ORIGINATION FORM

Index Number: 521-427
Sheet Number (s): 1 - 5
Index Title: Traffic Railing (36" Single-Slope)

Summary of the changes:

Renumbered Sheets 1-4 and added NEW Sheet 5 for Drainage Slot Details

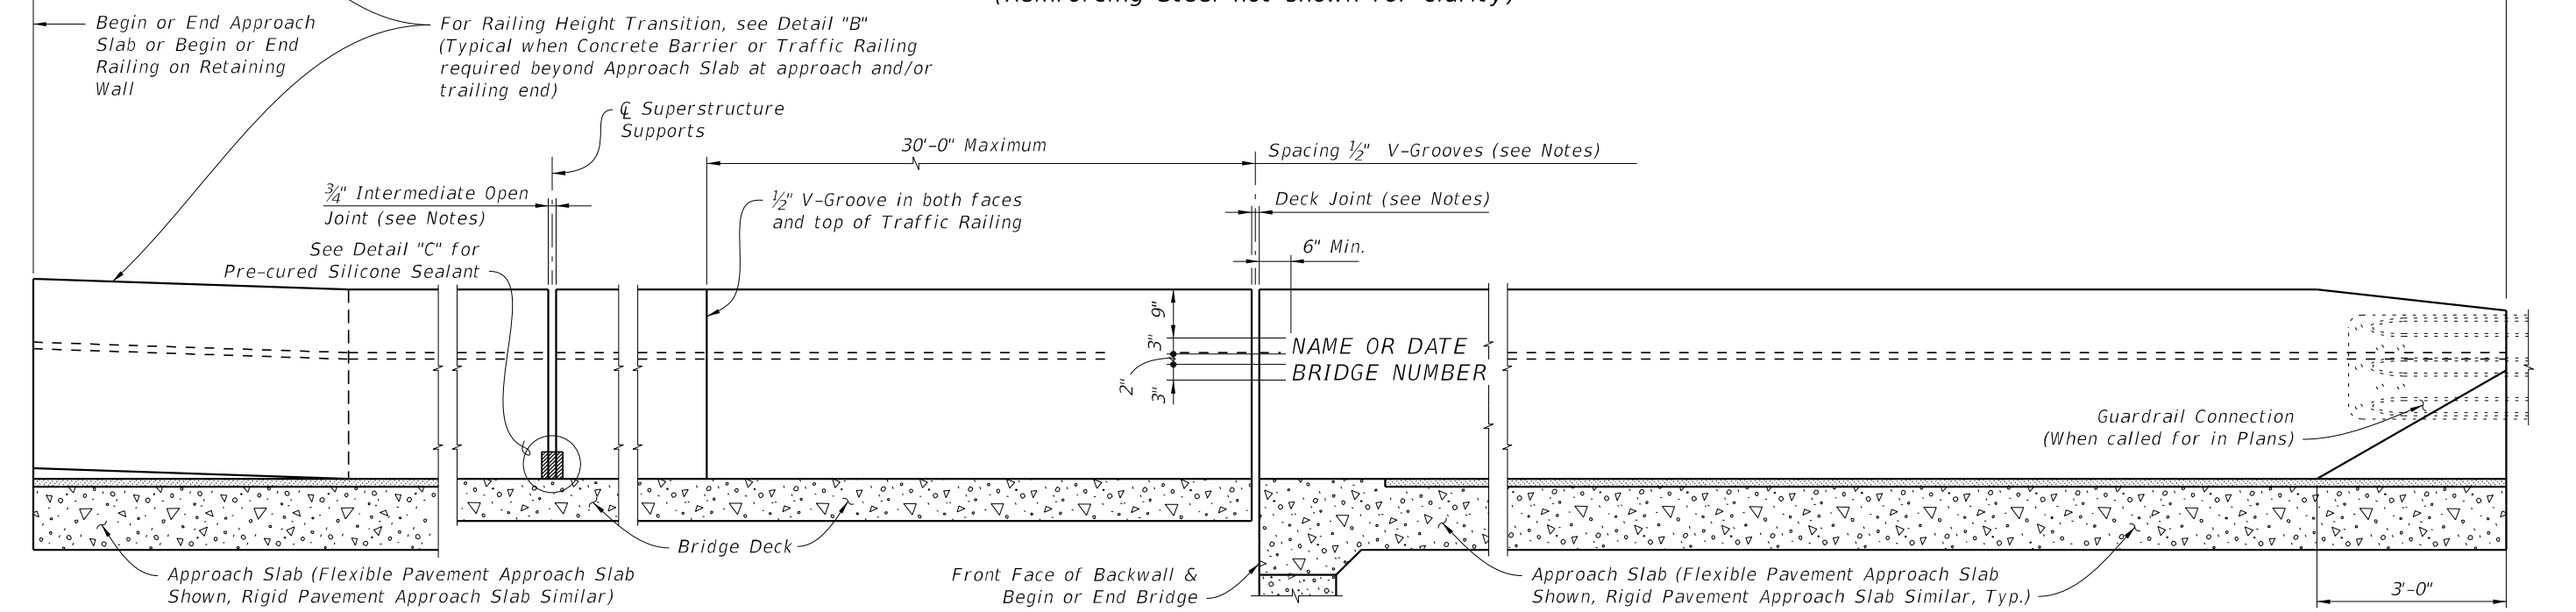
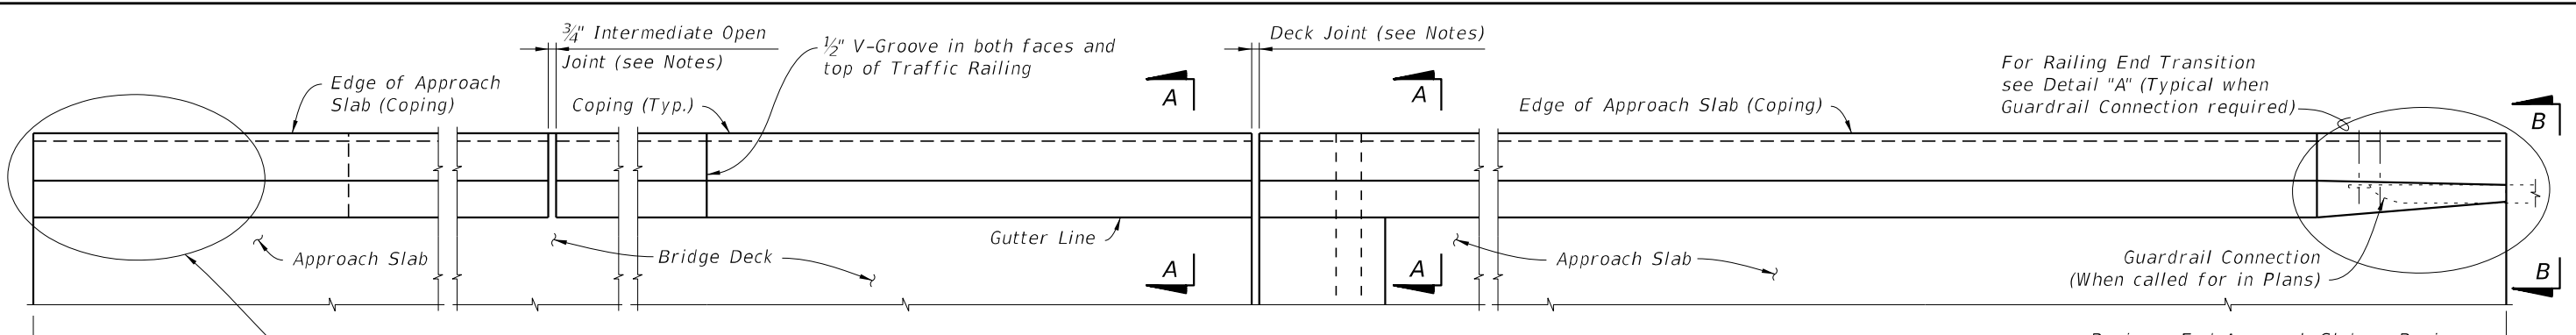
Added new sheet 5

5
1 of 4

SHEET
5 of 5

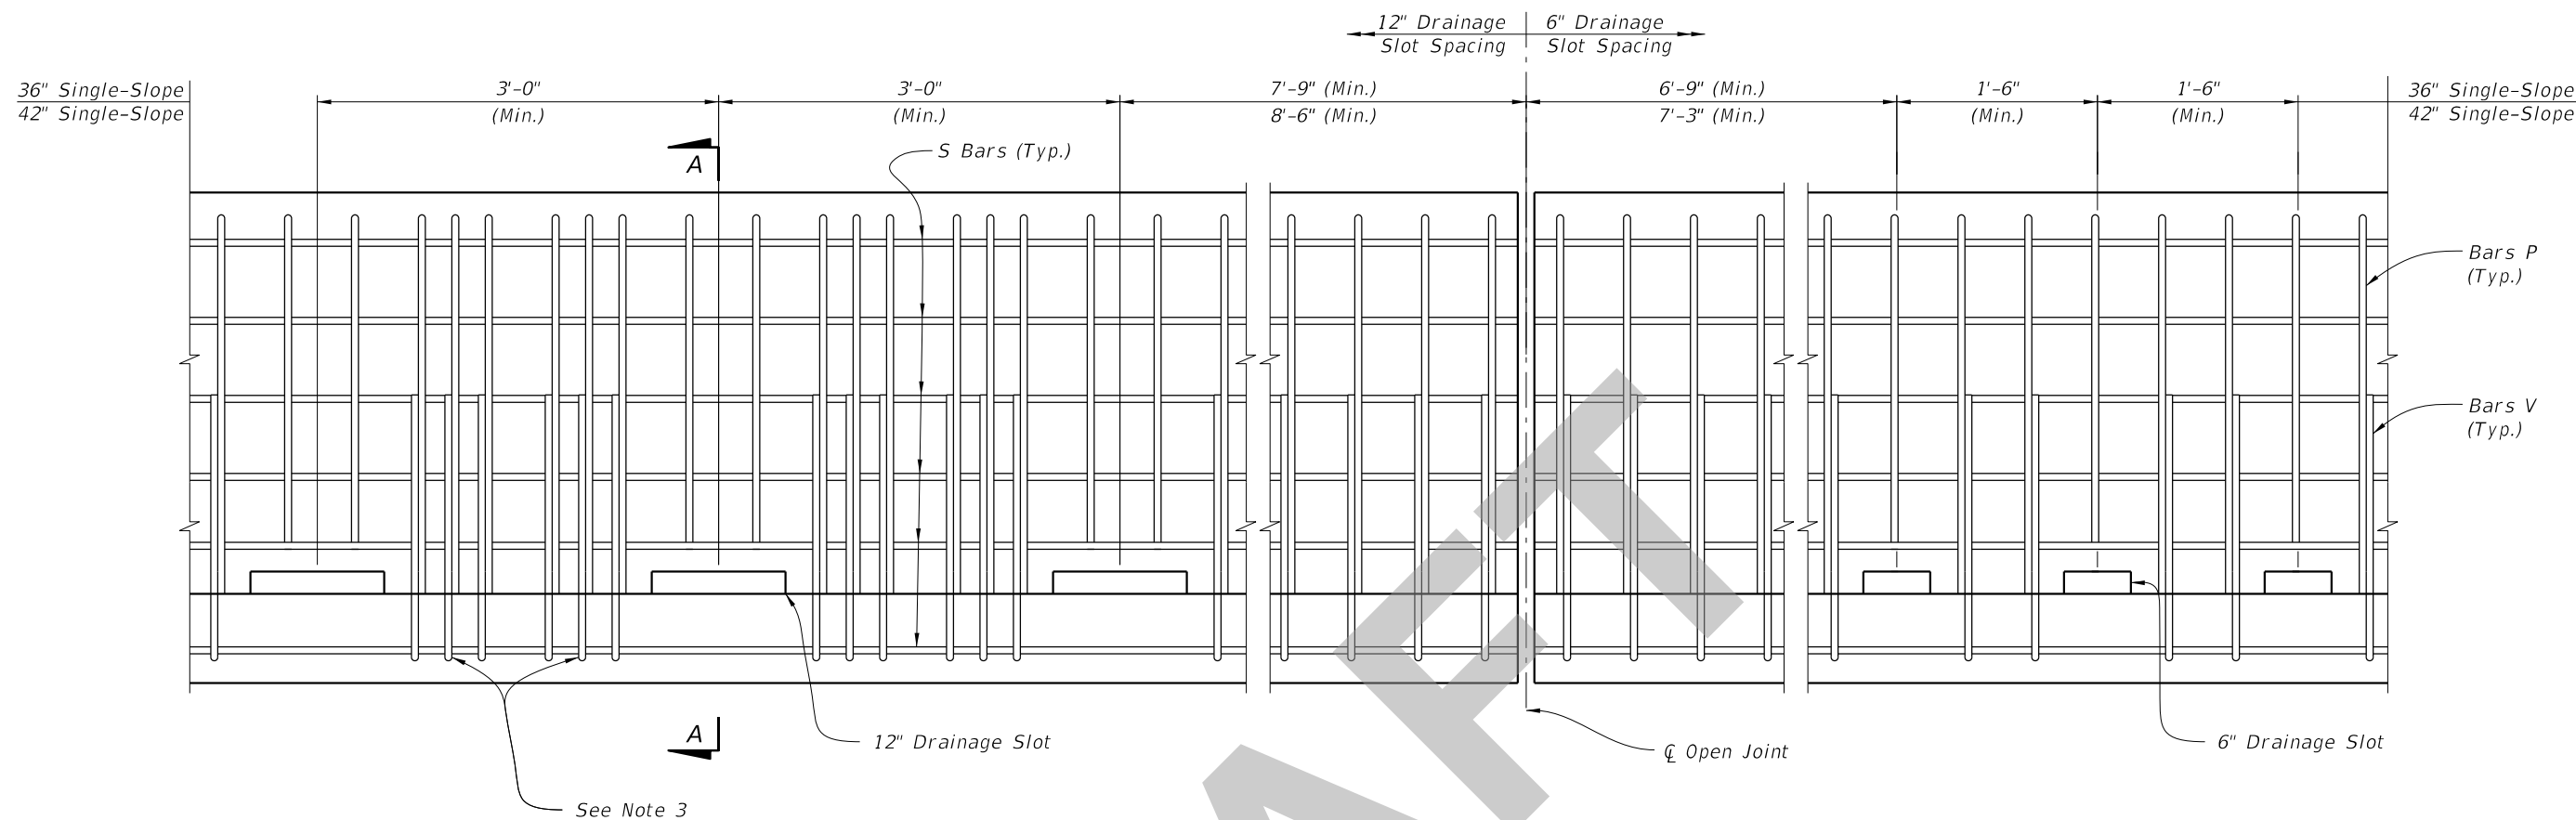
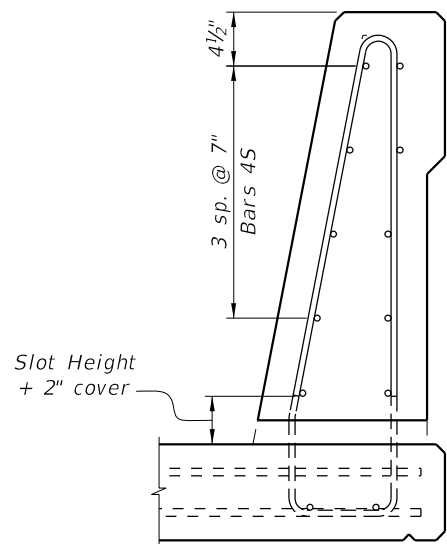
Per multiple requests from Districts, added Drainage Slot Details.

1. Use only when required for safety. See Plans for locations and size of drainage slots.
2. Maintain 2" minimum cover to all reinforcing. Trim P Bars over drainage slots and raise bottom S bars as necessary to maintain cover.
3. For slots greater than 6" in length, add additional vertical bars (V & P) on each side of the opening.
